## Site Technical Query - Form

TQ Number:		Project:	
<b>CW2148472 -A010- 0040</b>		<b>Oyu Tolgoi Underground Project</b>	
A. To be completed by or on behalf of the Contractor			
Contractor/Sub-Contractor Name:	MCS International	Date Response Required: (dd/mm/yyyy)	06/08/2022
Contract Title:	Haulage Truck Workshop /C-004D/	Plant Area & No:	1883
Contract No.	CW2148472	Contractor TQ Number:	TWS-0415-TQ-0040
Discipline Codes (Mandatory) <b>D1</b> (CSA) - <input type="checkbox"/> <b>D2</b> (MP) - <input checked="" type="checkbox"/> <b>D3</b> (E&I) - <input type="checkbox"/> <b>D4</b> (Other) - <input type="checkbox"/>			
<i>Description of Technical Query (List affected drawings and specifications):</i> <b>Subject: To change the pipe support type SD-106 to F1 located in the Oil room</b> The designed pipe supports for 1883-FW-2730-G2F-002", 1883-FW-2732-G2F-001" and 1883-FW-2733-G2F-001", sprinkler line are marked as SD-106 on the drawings of 1883-50-T1-1121. On the drawing of 1883-40-B1-1102, designed pipe support types are F1.

YORK CLAMP  
ROOF SUPPORT (F1)

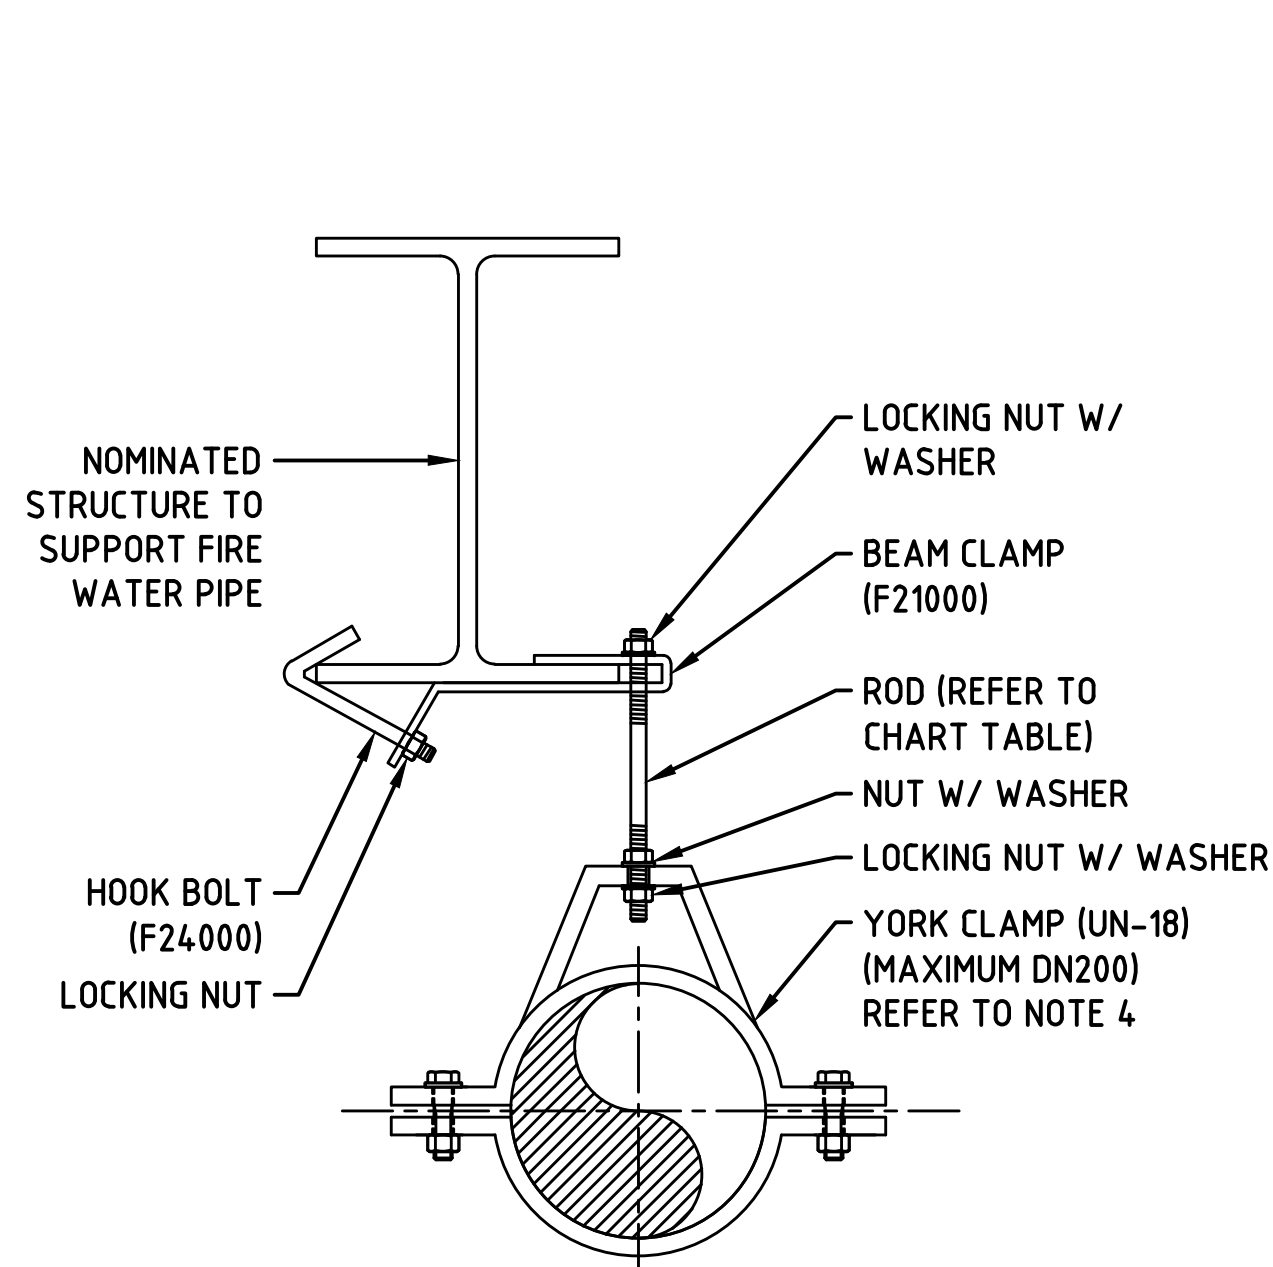
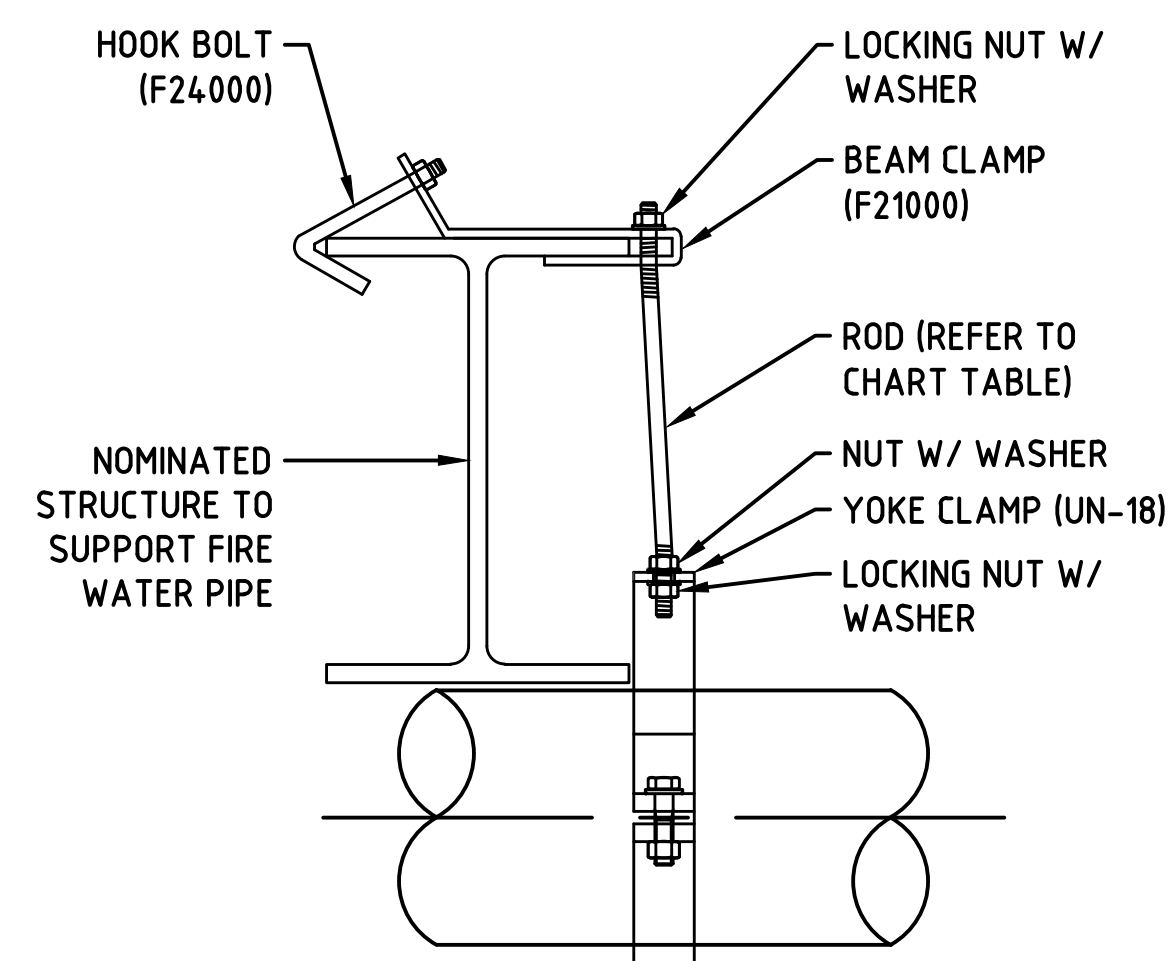
<input type="checkbox"/> Routine <input checked="" type="checkbox"/> Urgent Refer Technical Query instructions			
<i>Proposed Action (List all attachments)</i>  1. The contractor proposes that pipe support type SD-106, as shown on Attachment-1, be replaced with pipe support type F1 as shown on Attachment-2. 2. Also, designed the pipe support clashed with hydraulic oil pipes 1883-OH-2201-S4B-1.5"-NI on the Attachment-1. Therefore, contractor proposes to move 1.2 meters to the right.  <b>Attachments:</b> 1. 1883-50-T1-1121_1 2. 1883-40-B1-1102_2 3. 0000-50-N1-1112_1 4. 0000-40-B1-8005_2			
Effect on cost (USD):	NO		
Effect on schedule (Days):	NO		
Effect on quality:	NO		
Requested by (Name):	Dumburmaa.N	Position:	MP Field engineer
Signature:		Date: (dd/mm/yyyy)	06/05/2022

Proposed action is accepted
